APPLICATION FOR RESOURCE CONSENT OR FAST-TRACK RESOURCE CONSENT

Prepared for: Matthew Paraha
By: Andrew McPhee | Consultant Planner
Reviewed: Steven Sanson | Consultant Planner
Date: 1 July 2024

1. Changes to Condition 1 in relation to the approved plans by Relocate.
2. Changes to Condition 5 in relation to the requirement to upgrade the vehicle crossing with Mangakahia Road to a New Zealand Transport Agency.

3.3 Proposed Change of Consent Conditions

6277B MANGAKAHIA RD
PT MOTATU
5E11 BLOCK

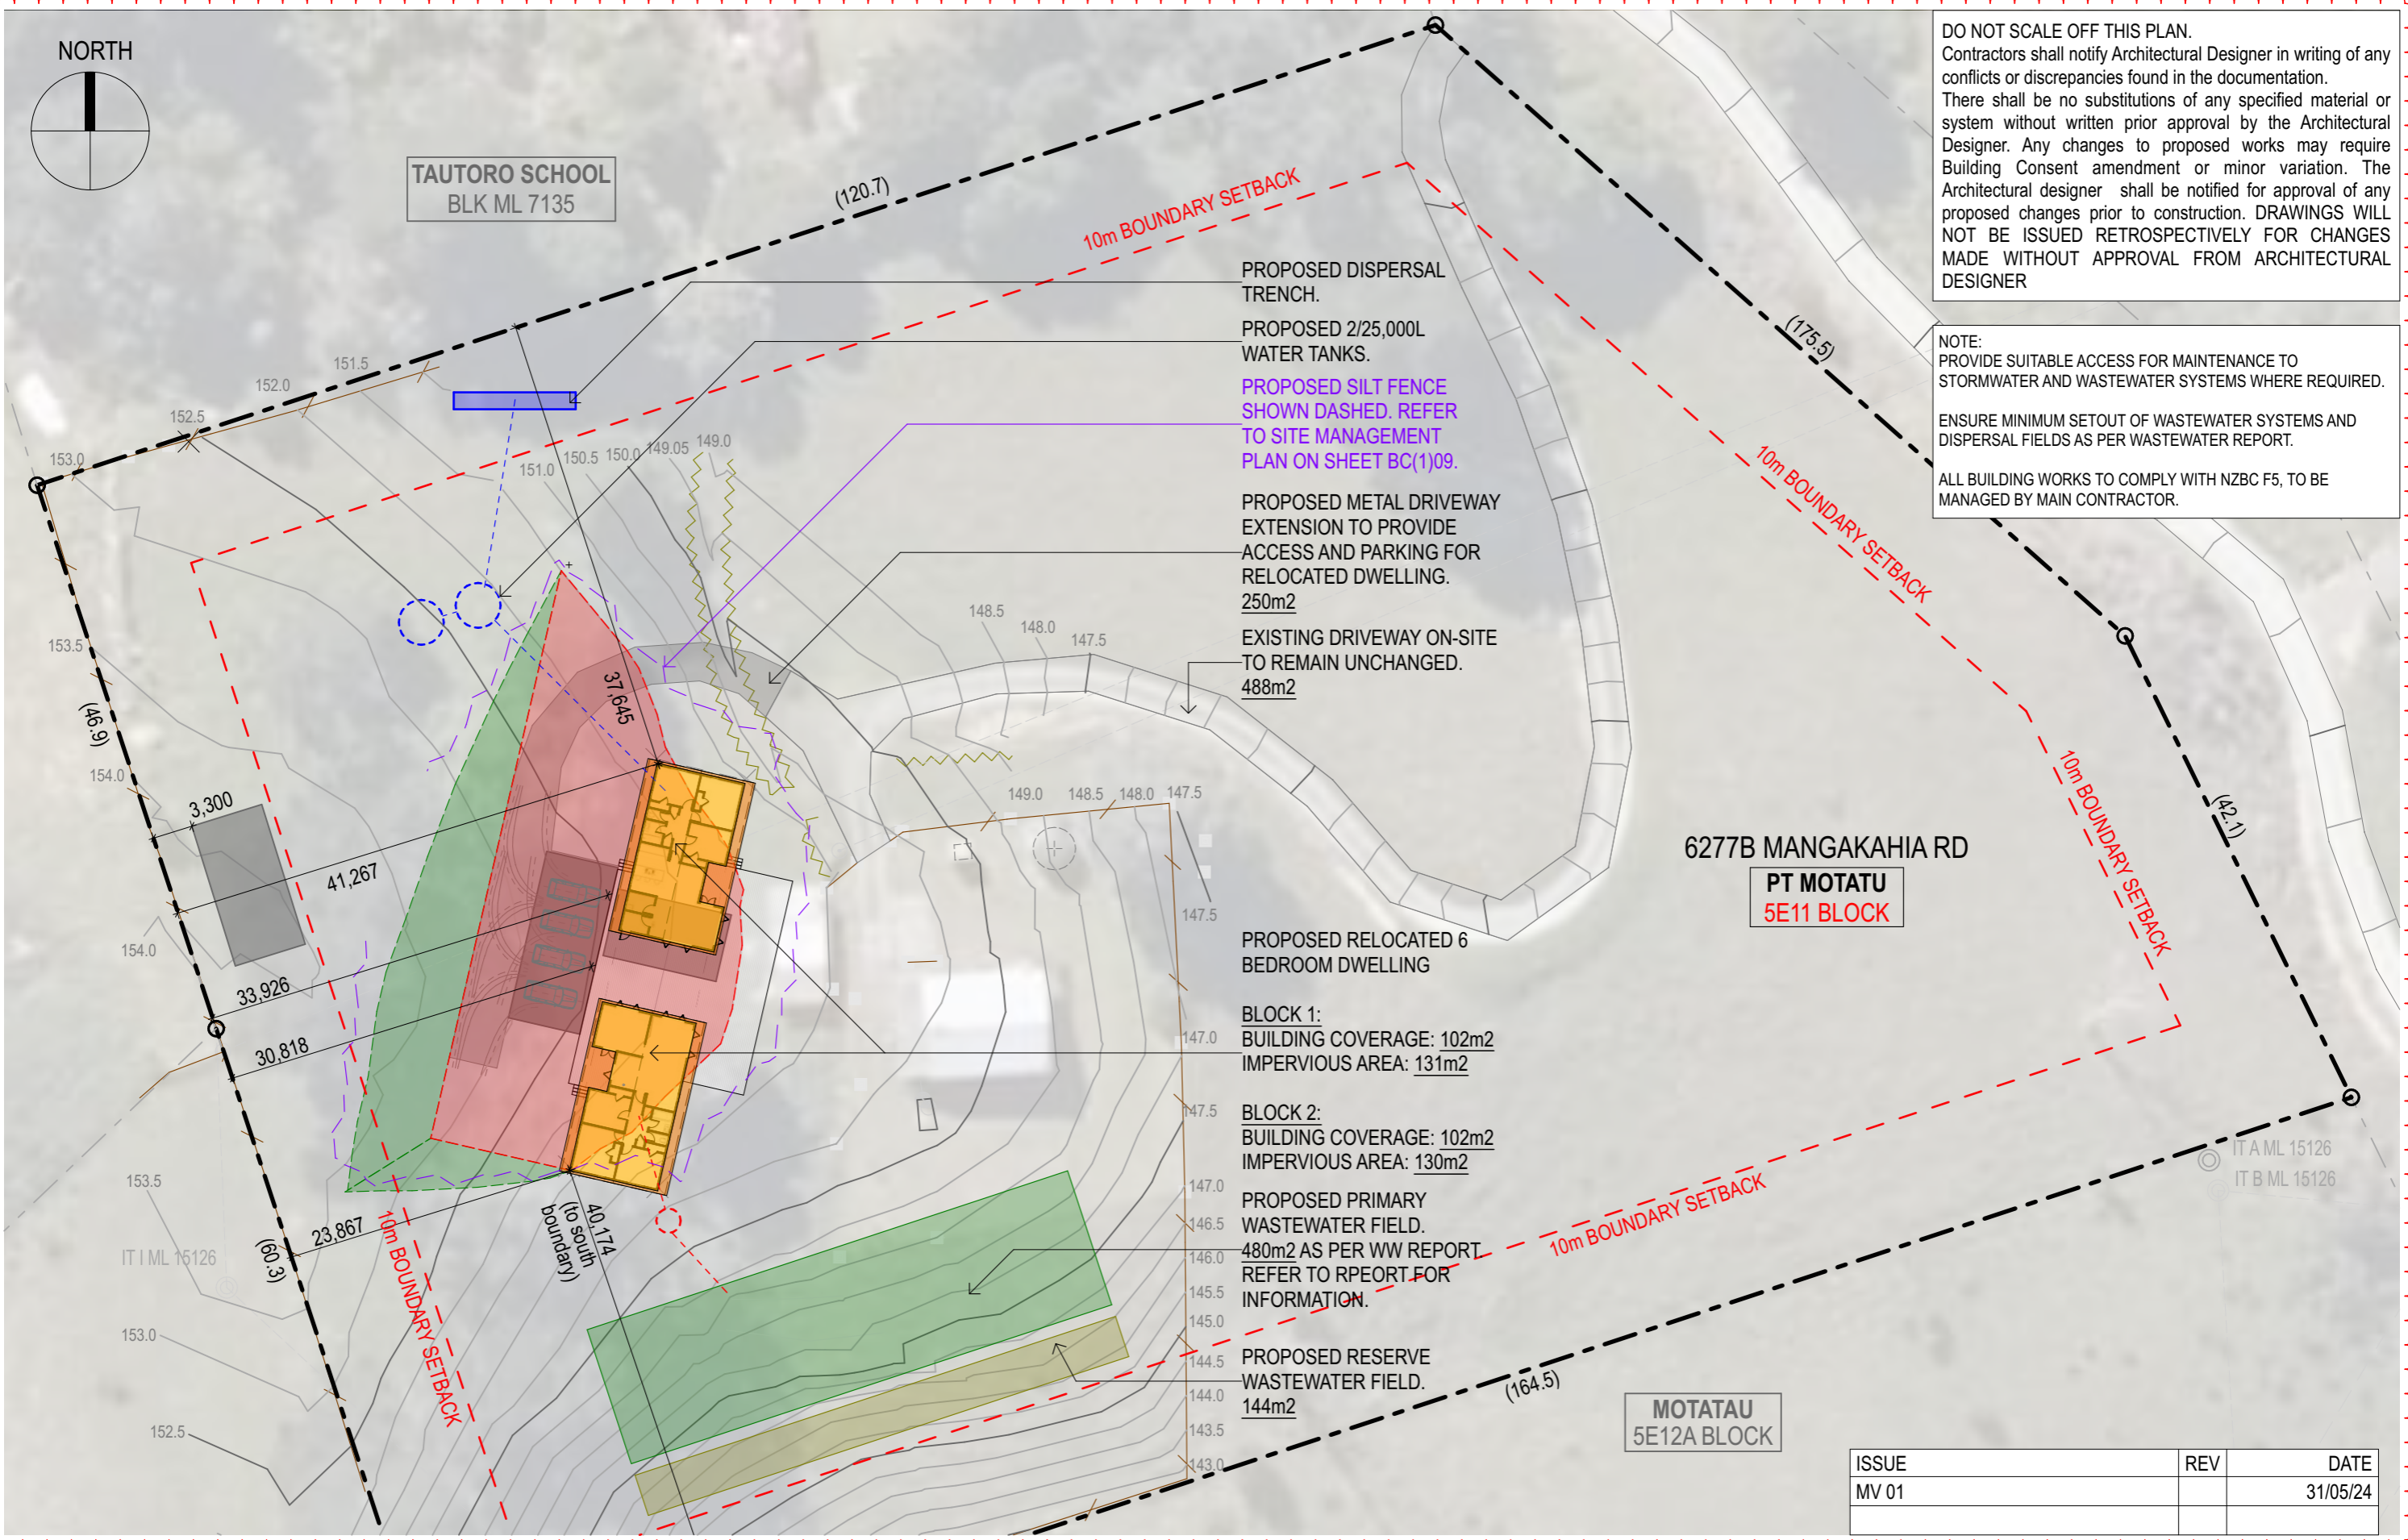
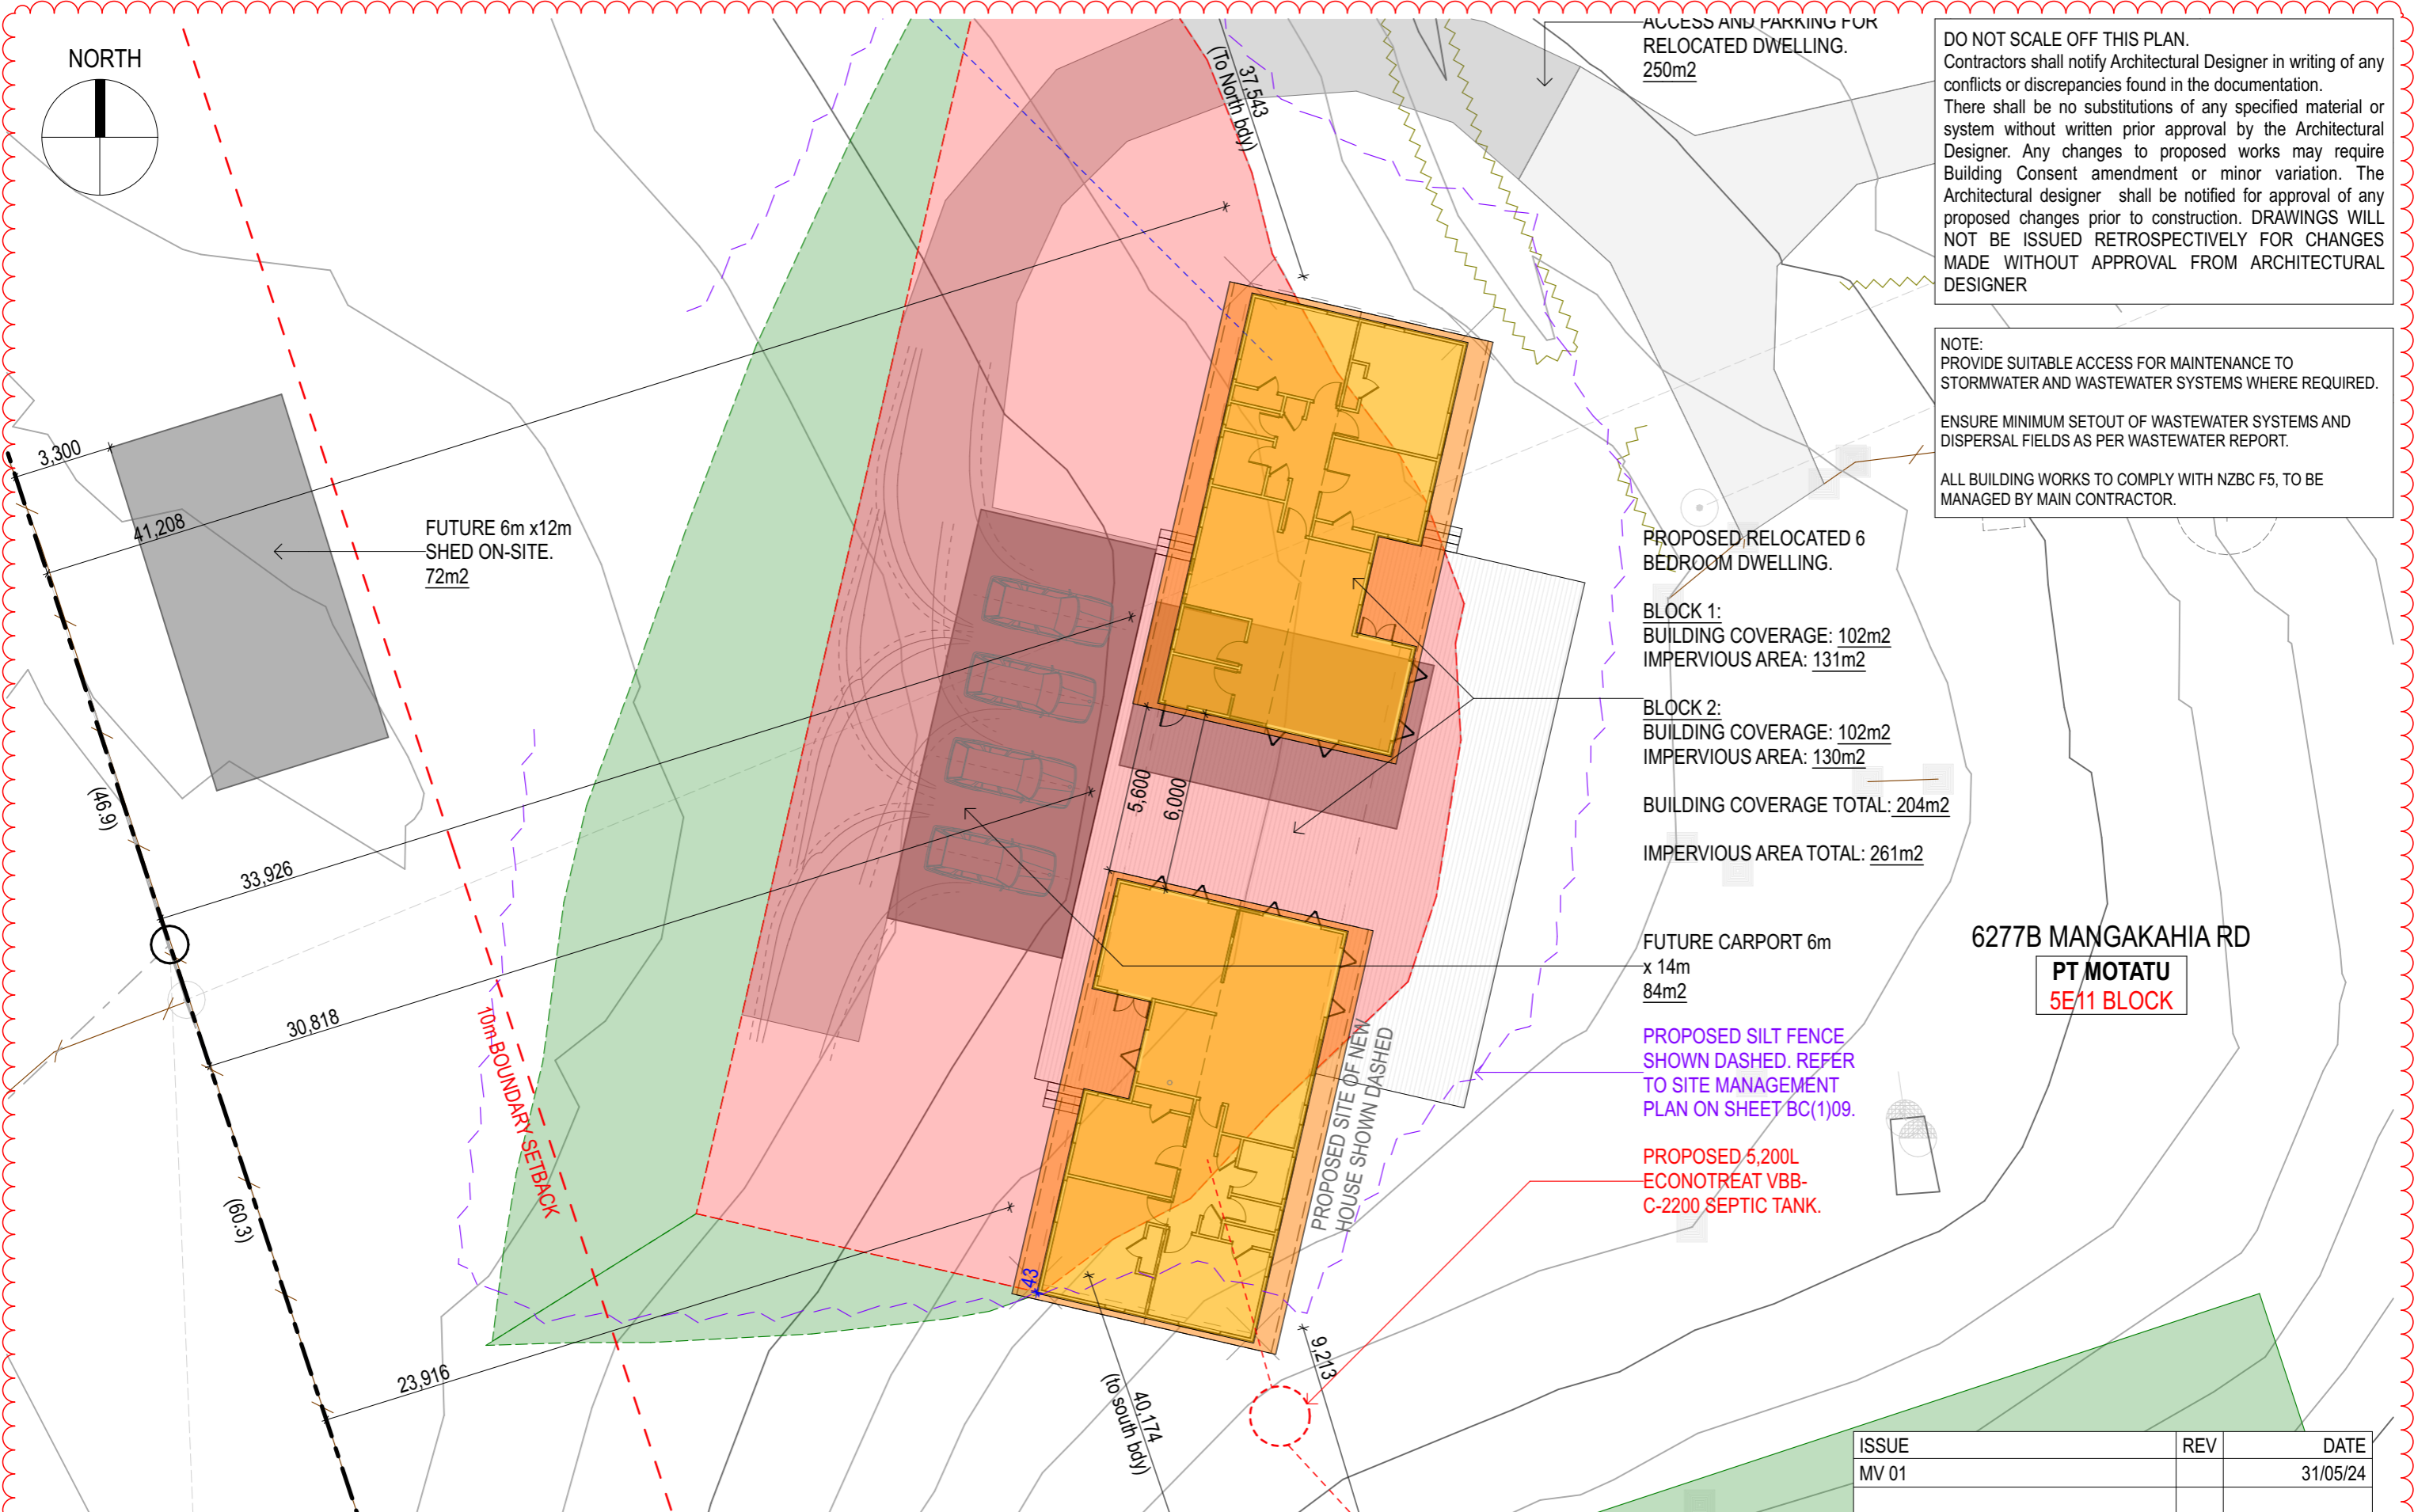
The proposed minor change of location for the proposed dwellings is not considered to result in any change or additional effects.

1. The works shall be carried out in accordance with:
 - a. The approved plans by Relocate It Reference Project No. 2304, Sheets BC(1)003 to 08, BC(1)13, and BC(2)00 to BC(2)05 dated ~~30/11/2023~~ 31/05/24 attached to this permit/consent with the Council's Approved Stamp affixed to them.

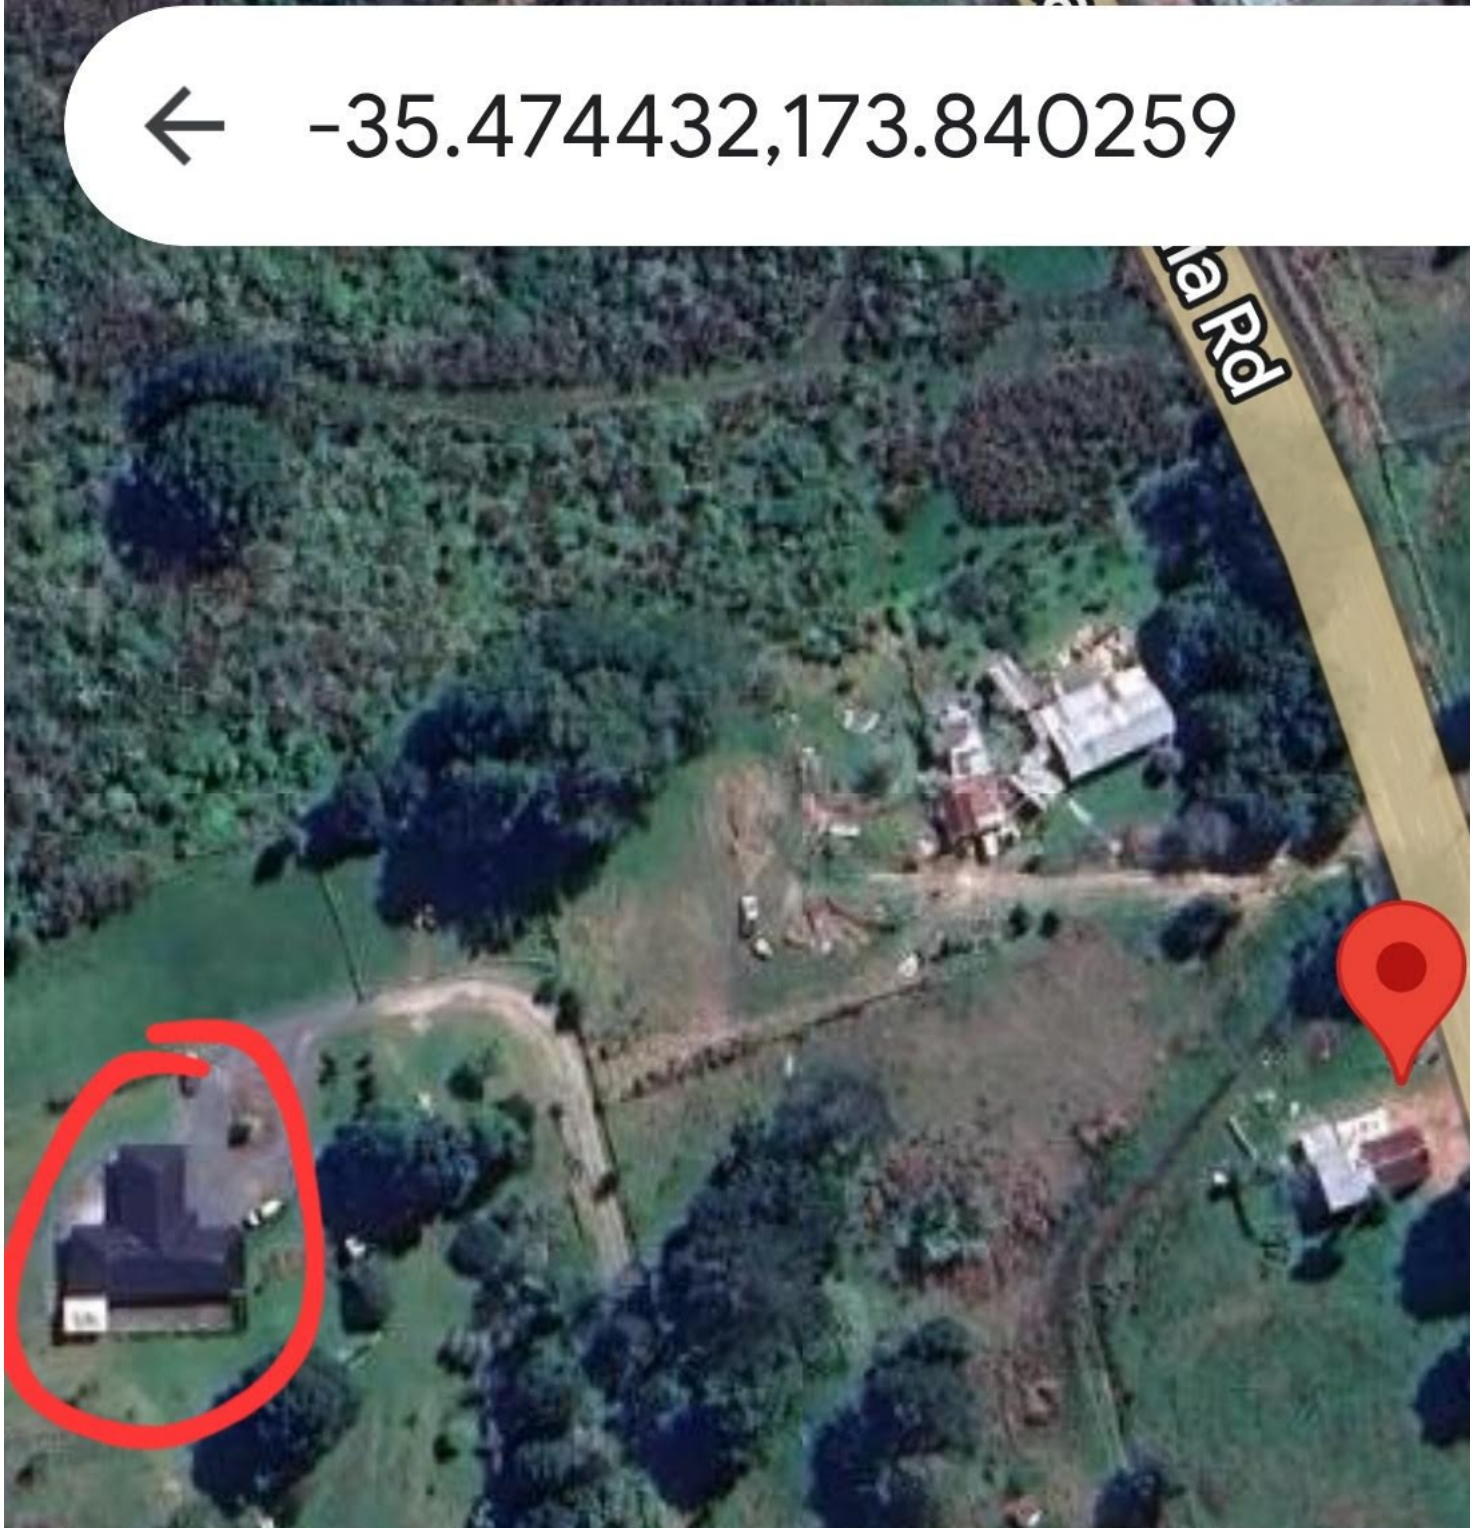
The reason the house in blue has access from the back of her house up the paper road is because her son was living in the house in yellow for many years and our whanau onto the paper road.

He has since moved away and the house in yellow has now been removed, it is currently being stored on the area marked green till it can be removed completely.
